OBJECTION TO PLANNING APPLICATION 2026/0447 from POSITIVELY HERSHAM, a sub- committee of HERSHAM COMMUNITY GROUP

This is an objection against Planning Application **2026/0447** regarding land to the South of 131 to 147 Burwood Road Hersham. This objection is one of several objections , sent under separate cover.

This particular objection is in relation to PROPOSED FOOTWAY along the south of Burwood Road

Detail of highway and ditch adjoining proposed development (to scale)

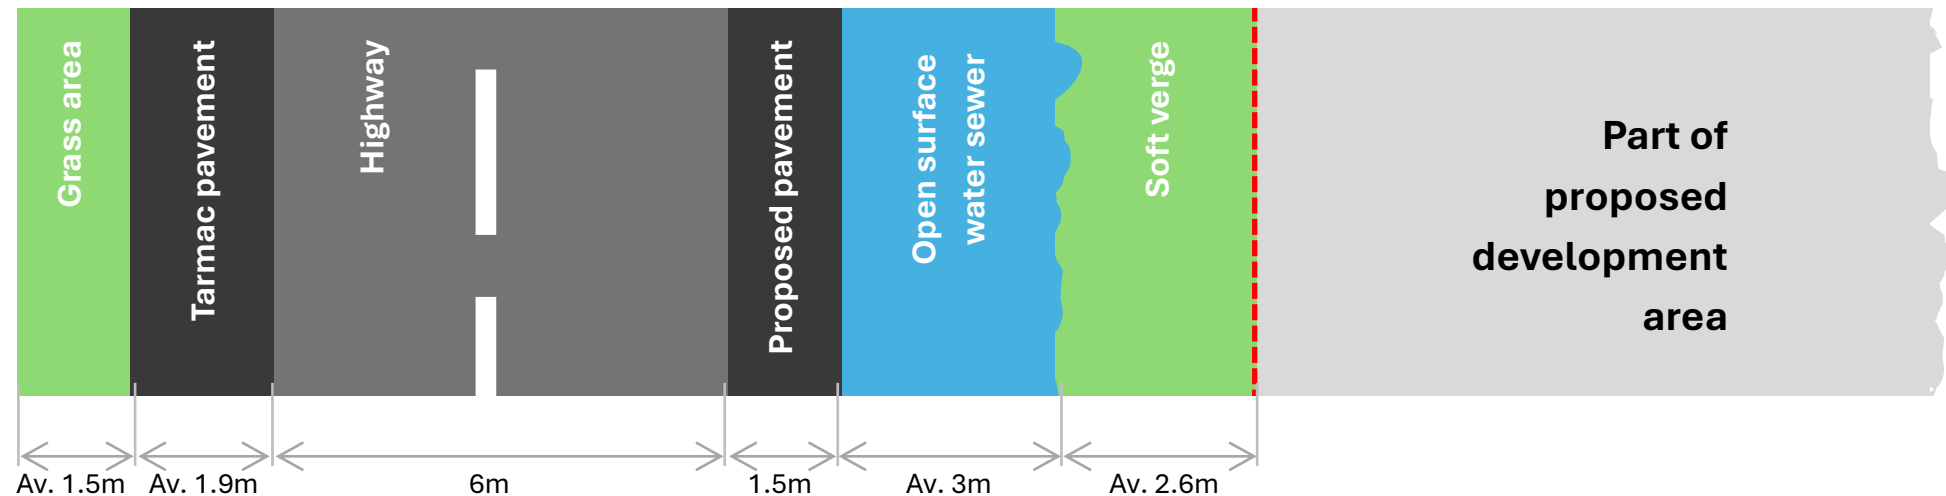
Whilst it is acknowledged that the Site Access plan is a proposal, it is also true to say that any proposal must consider the topography of the land in question and in this case there is no proposal to alter the course of the ditch in any way.

It is a fact that the distance from the road kerb to the edge of the ditch varies between 1.3m and 1.5m across very soft verge **see photo 3**. In order to achieve a pedestrian walkway of 1.5m (as suggested by the applicants) including a retaining wall to support the path, it will be necessary to undertake very substantial solid engineering works within a large part of the ditch, to the permanent detriment of the prime purpose of the ditch itself. The ditch is part of a SCC-Mapped Historic Wetspot.

The boundaries shown on the plans are inaccurate. The Highway Boundary is shown as being in the middle of the ditch but we believe that the boundary is the kerb on Burwood Road. The applicant boundary is also shown as being in the middle of the ditch. It is not, as evidenced by Land Registry. We believe the boundary of the applicant owned land is approximately 7m from the road kerb. It would seem that the applicant is relying on consent from unknown third-party ownership but it is not possible for a planning permission to place conditions on unknown third parties.

Cross sections (to scale)

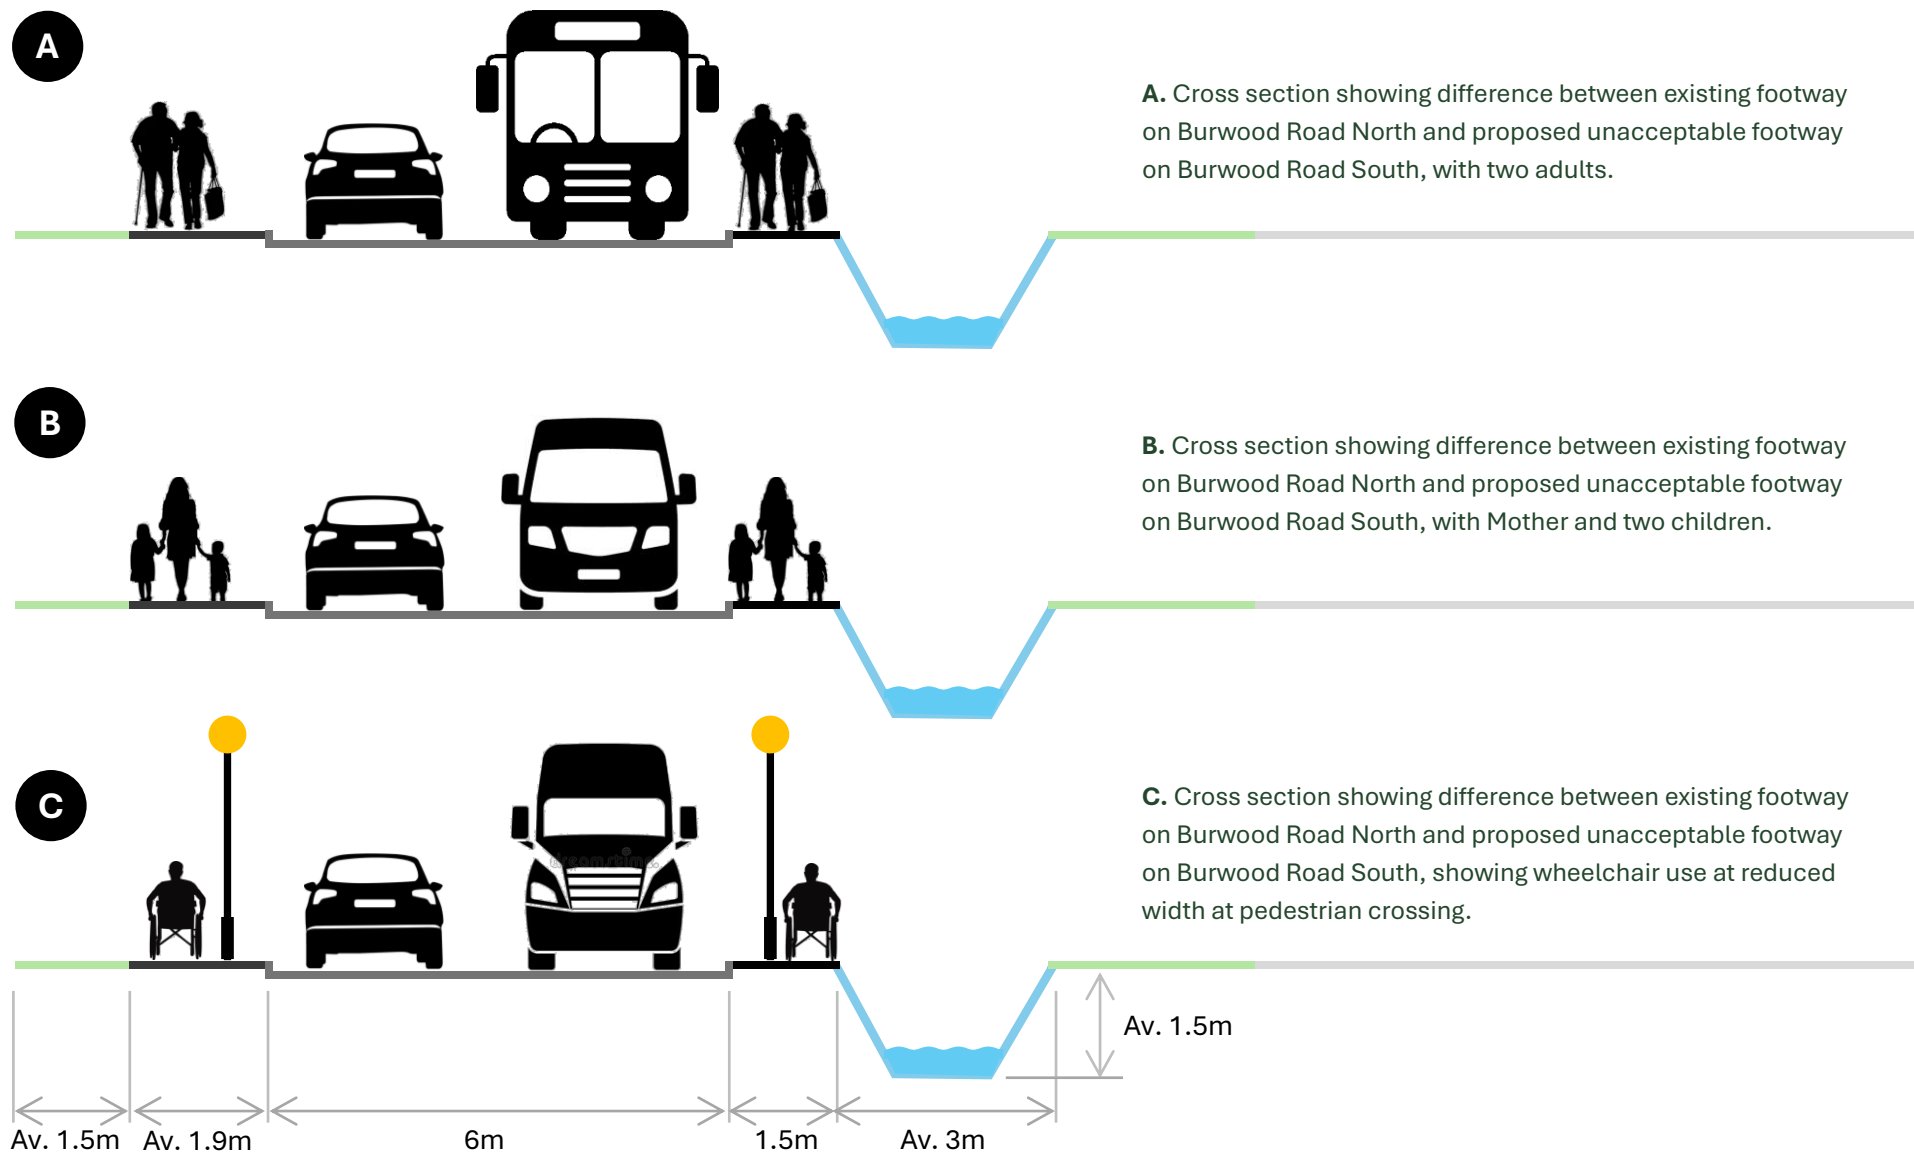
In addition, in view of the street furniture required for a pedestrian crossing and other lighting, the applicant shows on their plan that the width reduces to just 1.0m. With this in mind it is noted that the applicants have chosen to provide a Zebra crossing rather than a Controlled crossing which will require even more street furniture and create even more blockage to the free passage of pedestrians.

See cross section C.

This is an application for a new development on previously undeveloped land. At the very least it should comply with modern standards. It does not. The proposed new footway of 1.5m (even if it was possible to build), has an immediate unprotected drop into a deep open ditch. It, therefore, follows that the proposal gives rise to:

See cross sections A,B and C
